All Commercial BEECHCRAFT Models

No. 2405
ATA Code 11-00
Recurring Inspection

SUBJECT: PLACARDS AND MARKINGS - INSPECTION TO VERIFY INSTALLATION AND CONDITION OF ALL INTERIOR AND EXTERIOR PLACARDS AND MARKINGS.

SUBJECT: FLIGHT CONTROLS - INSPECTION OF FLAP DRIVE CABLE/FLAP DRIVE MOTOR COUPLING CONNECTION

**Flap Drive Cable/Flap Drive Motor Coupling Connection
Figure 1**

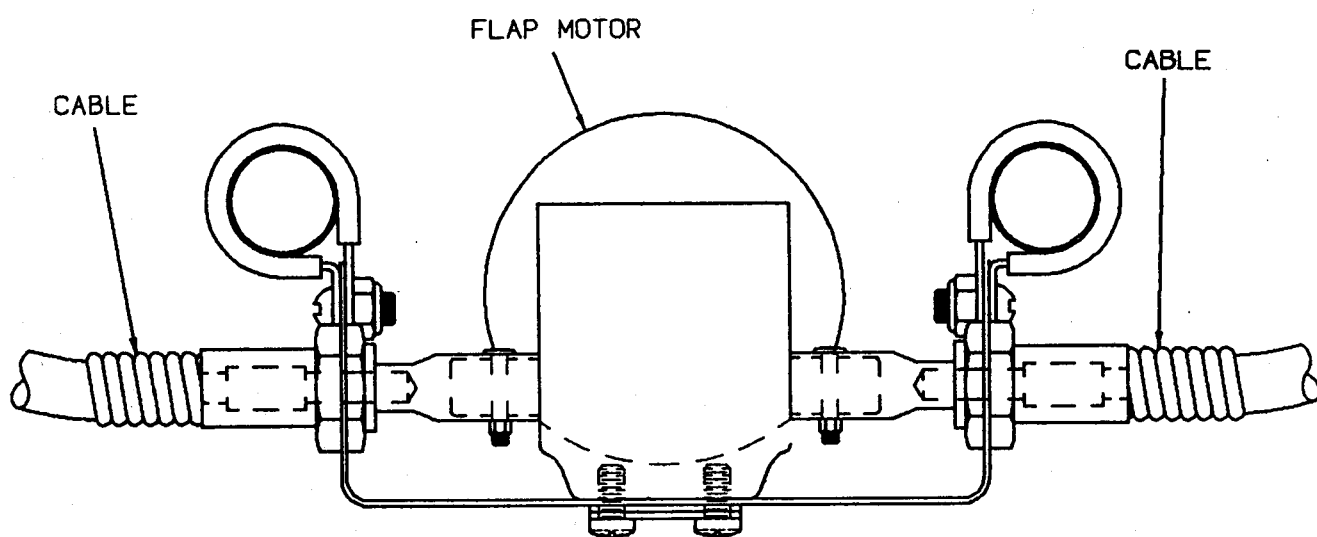
- a. The flap drive cable configurations shown in Figure 1 are not affected by this Service Bulletin. If the airplane is configured as shown in View A or View B of Figure 1, proceed as follows:

AIRPLANES WITH EITHER OF THESE
CONFIGURATIONS ARE NOT AFFECTED
BY THIS SERVICE BULLETIN.

- 1) Replace all seats and equipment that were removed to gain access to the flap drive motor.
 - 2) Restore electrical power to the airplane and ensure that the flap system operates properly.

Flap Drive Cable/Flap Drive Motor Coupling Connection
Figure 2

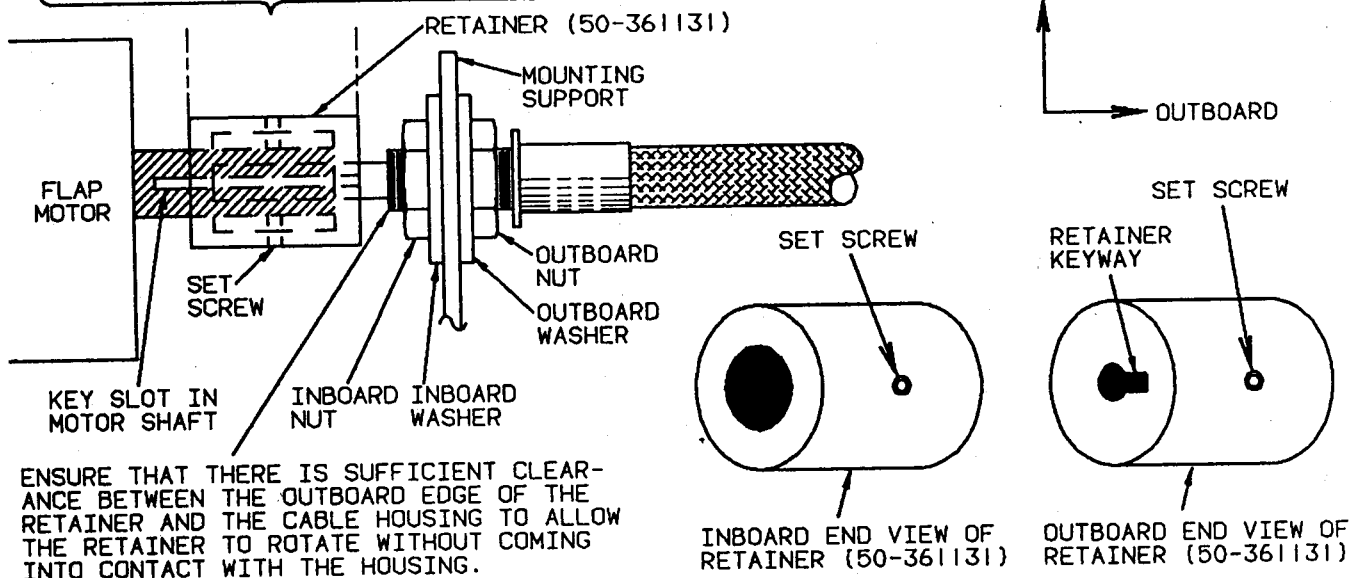
- b. If the airplane is configured as shown in Figure 2, proceed to Step 5.
5. Verify that retainers are installed and cable housings and hardware are arranged as shown in Figure 2. Ensure that the keyway slot is rotated 90° relative to the slot in the motor drive shaft. Clearance must exist between the outboard end of the retainer and the inboard

end of the flap cable housing. If retainers are not installed and/or if flap cable housings need to be repositioned, proceed in accordance with the FLAP DRIVE CABLE CONNECTION instructions in this Service Bulletin. Refer to the applicable Shop/Maintenance Manual for instructions to disconnect the flap cables from the flap motor drive shaft.

MODEL 60 AIRPLANES ARE EQUIPPED WITH A SPRING IN THIS LOCATION. ENSURE THAT THE SPRING IS INSTALLED.

AIRPLANES WITH THIS CONFIGURATION ARE AFFECTED BY THIS SERVICE BULLETIN.

1. Connect the LH and RH flap drive cables to the flap drive motor as follows, using Figure 2 for component locations:
 - a. Install the outboard nut and washer as far as it will go on the threaded portion of the flap cable.

- b. Insert the retainer through the mount support and onto the motor shaft as far as it will go. Align the retainer keyway with the key slot in the flap motor drive shaft and tighten one set screw temporarily.

- c. While inserting the flap cable through the mount support, install the inboard washer and nut. Fully install the cable through the retainer and into the motor drive shaft until the keyway is just past the key slot in the retainer.

- d. Loosen the set screw that was tightened in Step b. Ensure that the retainer is still installed on the motor shaft as far as it will go and rotate the retainer 90°.

- e. Keep inboard pressure on the retainer and tighten both retainer set screws.
 - f. Secure the flap drive cable to the mount support by tightening the nuts. Tighten the inboard nut and ensure that there is sufficient clearance between the c

board edge of the retainer and the cable housing to allow the retainer to rotate without coming into contact with the cable housing. If the threaded part of the cable housing is not long enough to install the two nuts and washers, using a die, add 5/8-24 UNEF threads until .88 inch thread length is reached. Tighten the outboard nut against the mounting support.

Fuel Strainer Spring and Housing Plate

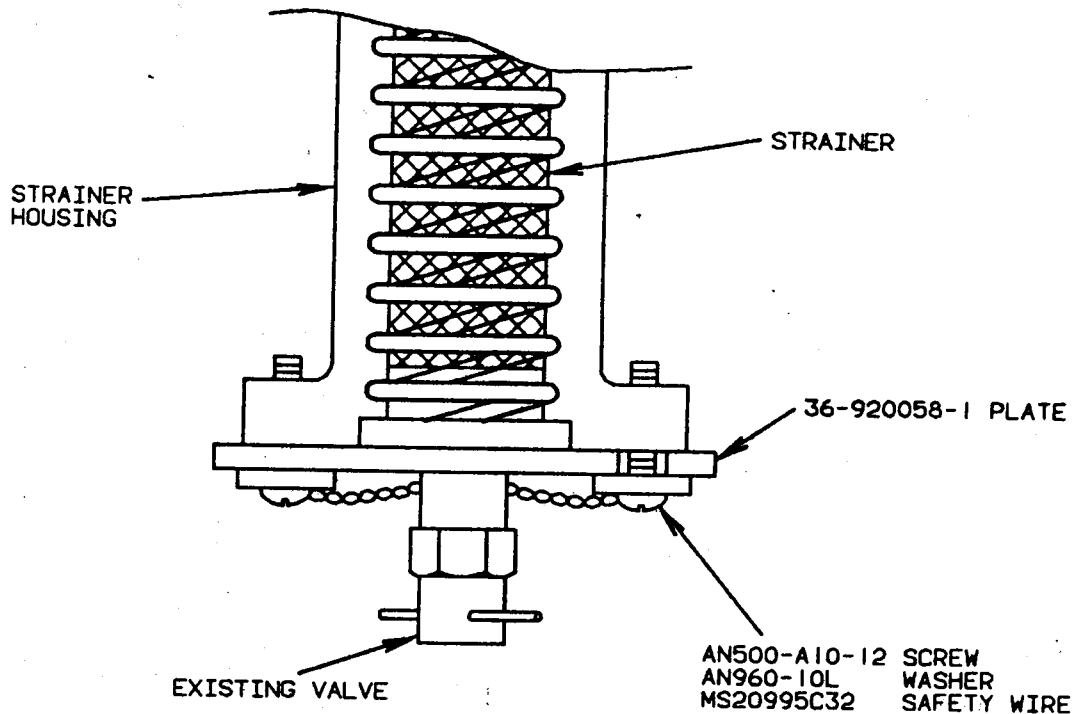
Revised EFFECTIVITY to include additional serials; COMPLIANCE; modified illustration in ACCOMPLISHMENT INSTRUCTIONS to clarify strainer installation; corrected pipe thread sealant part number.

This Service Bulletin is being issued to replace the fuel strainer spring and housing plate with an improved housing plate. The new plate and spring come as one assembly and will prevent the strainer screen from being installed incorrectly. An incorrectly installed strainer screen may allow unfiltered fuel to enter the fuel system. Unfiltered fuel may contaminate the engine fuel system and cause engine power interruptions.

1. Turn the fuel selector to the OFF position.
2. Gain access to the fuel strainer and remove the existing fuel strainer housing plate and fuel strainer spring from the bottom of the fuel strainer. See Figure 1. Remove and retain the valve from the housing plate and retain the attaching hardware. Discard the mounting plate, gasket and spring.
3. Use LOCTITE 592-31 (PST 592) to coat the drain assembly threads and install the valve into a new P/N 36-920058-1 housing plate. LOCTITE 592-31 (PST 592) is available through a BEECHCRAFT Authorized Outlet or may be procured from local sources.
4. Install a new P/N 35-921181 gasket on the new housing plate, place the strainer into

the spring (attached to the new plate) and attach the plate to the strainer housing using the two screws and washers which were removed in Step 3. Safety the two screws with P/N MS20995C32 safety wire (obtain locally).

Control Gust Lock Modification/Replacement
Figure 1

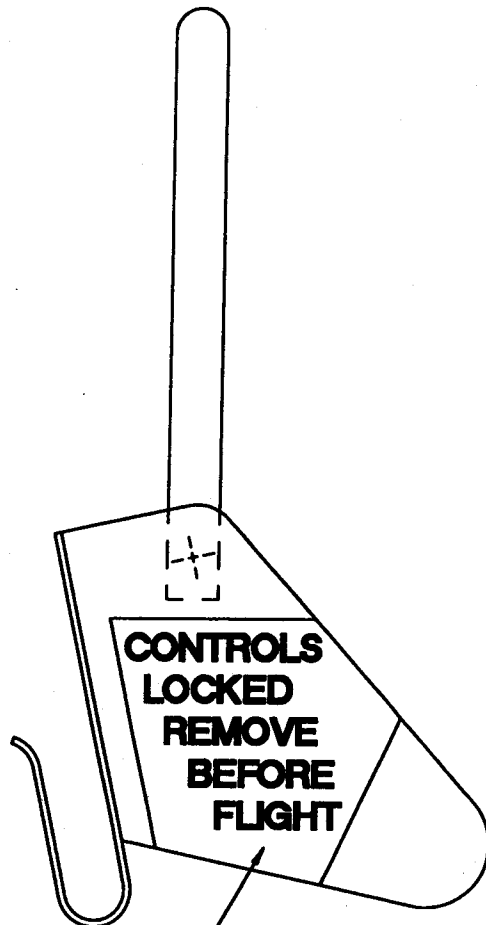
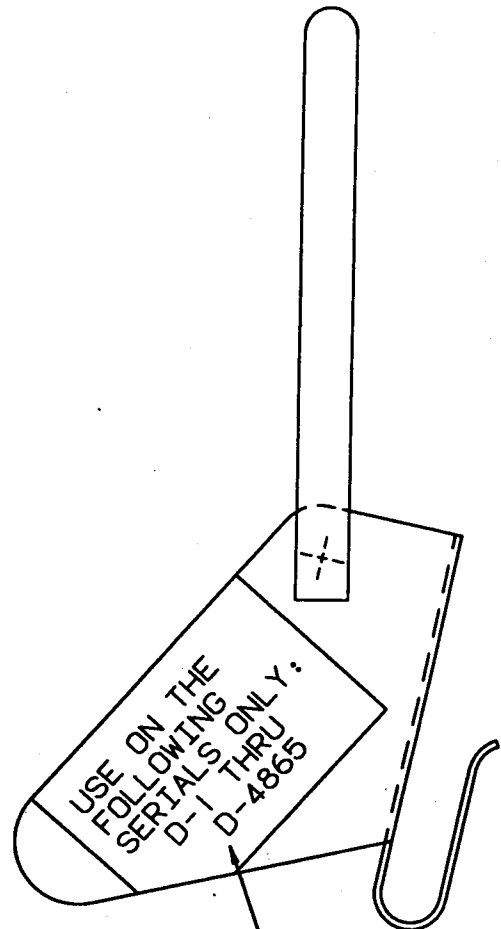
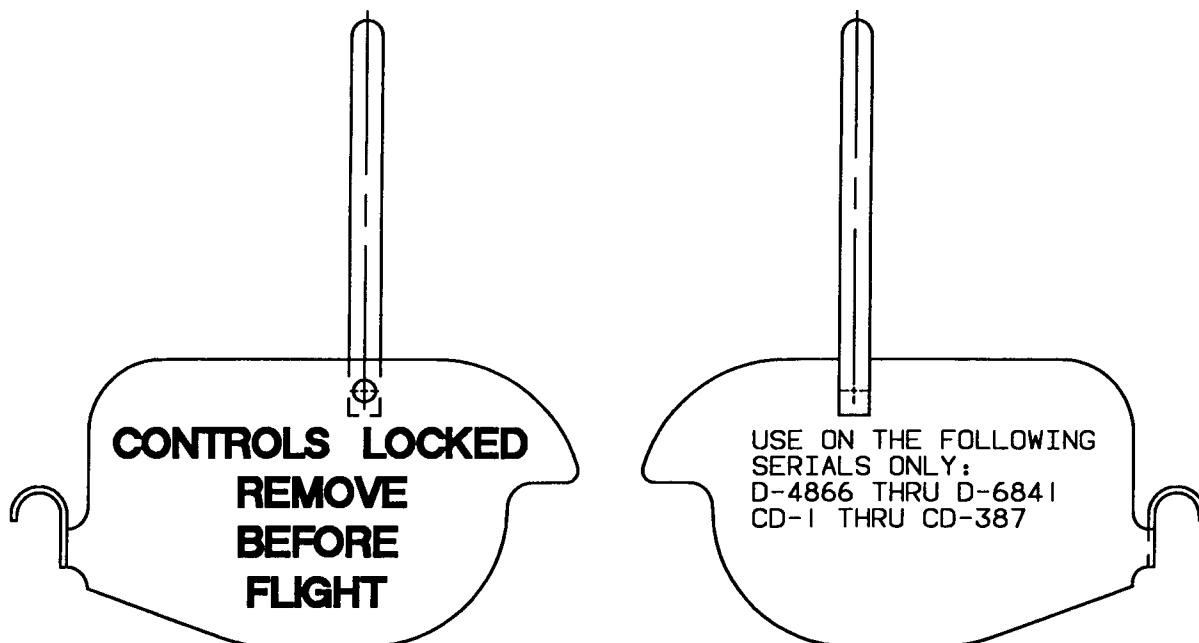
Serials D-1 through D-4865 equipped with the original P/N 35-5294190 control gust lock:

Serials D-1 through D-4865 that do not have a control gust lock:

Refer to Figure 1 and install a P/N 35-590125-3 and a P/N 35-590126-7 placard on the control gust lock. Install one placard on each side of the control gust lock.

Refer to Figure 1 and install a P/N 35-5294190-3 control gust lock. The P/N 35-524190-3 gust lock includes the P/N 35-590125-3 and P/N 35-590126-7 placards.

**Control Gust Lock Replacement
Figure 2**

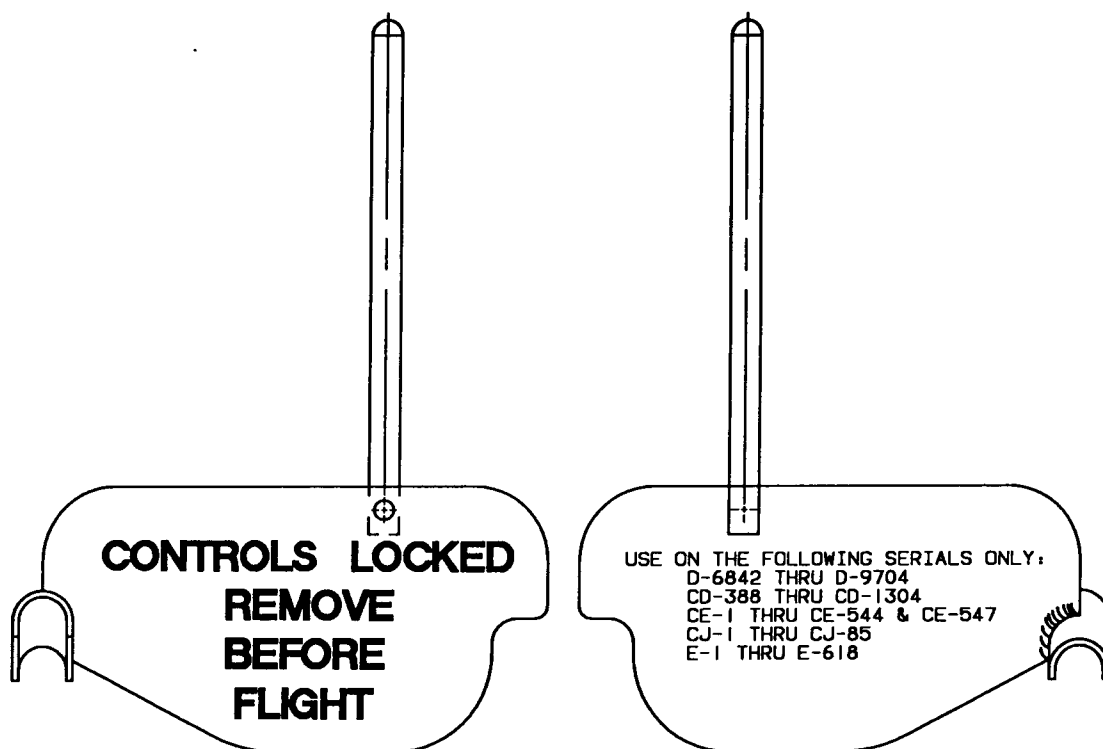
Serials D-4866 through D-9704, CD-1 through CD-1304, CE-1 through CE-544 and CE-547, CJ-1 through CJ-85, and E-1 through E-618:

Refer to Figure 2 and install the P/N 35-590127-1 or P/N 35-590128-1 control gust lock as applicable.

Nose Gear Door Retraction Mechanism Modification
Figure 1

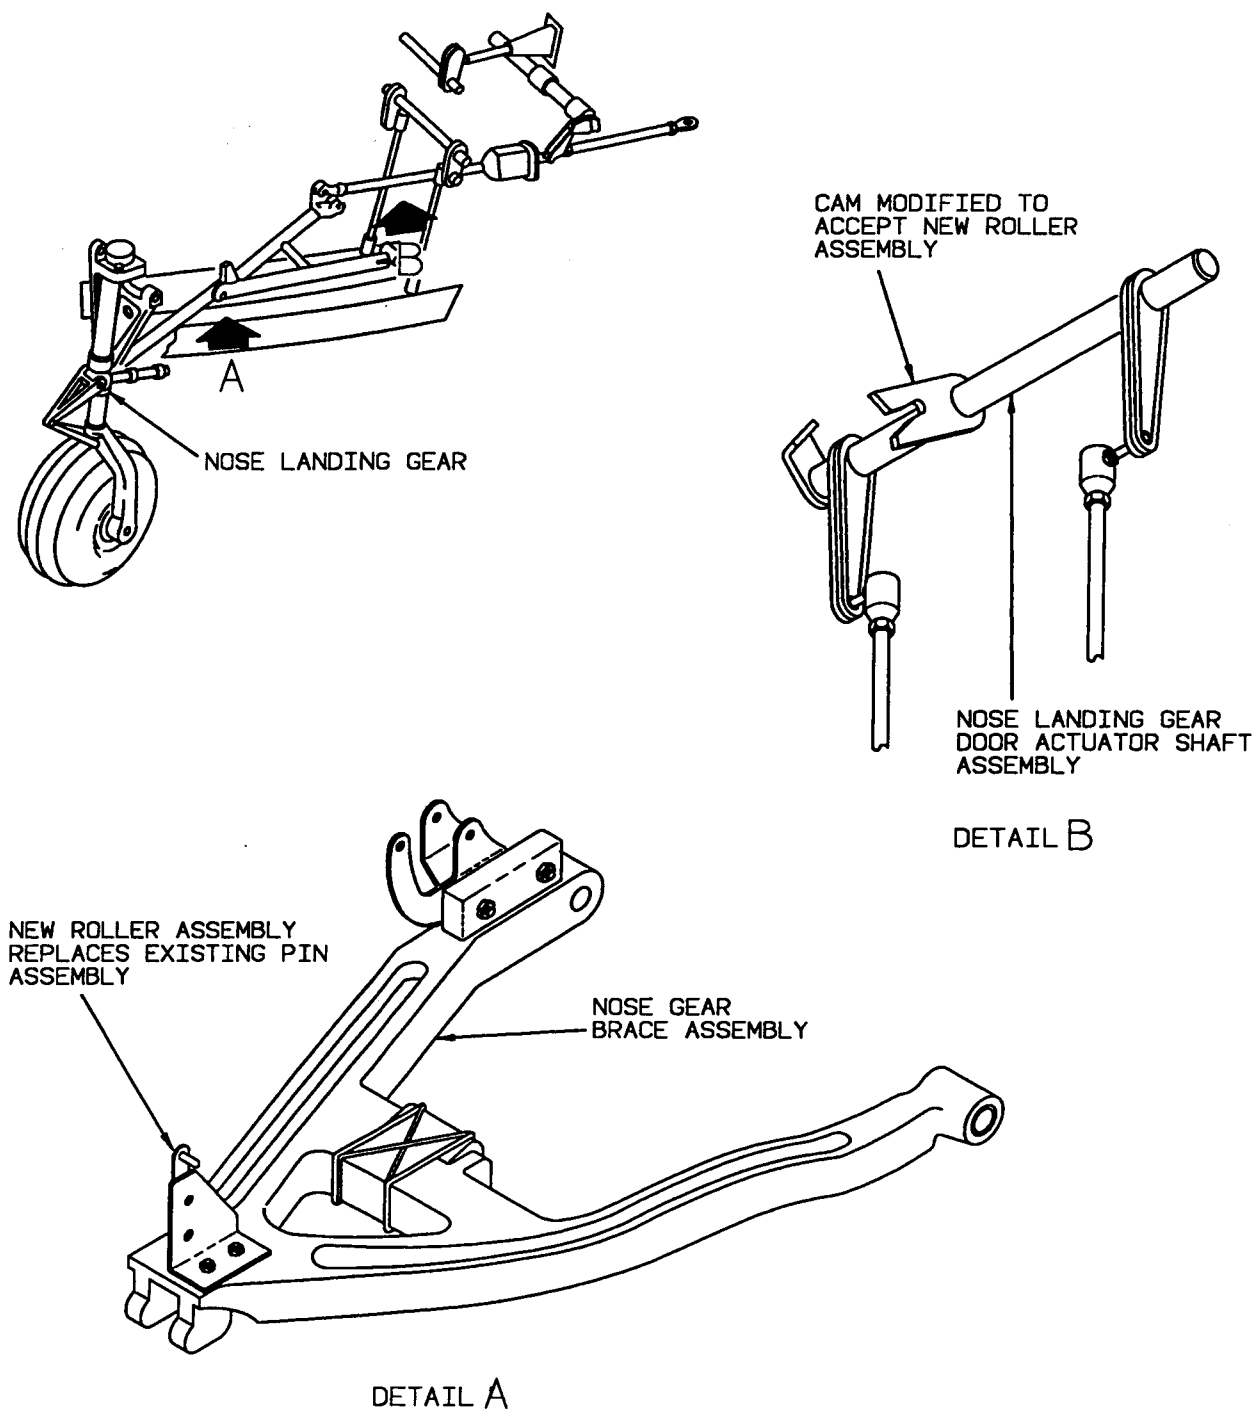
REASON: This Service Bulletin is being issued to announce a kit that installs a new roller assembly on the nose gear door retraction mechanism. Refer to Figure 1 for an illustration of the modification. The new roller assembly, when installed, improves the service life of the nose gear retraction mechanism.
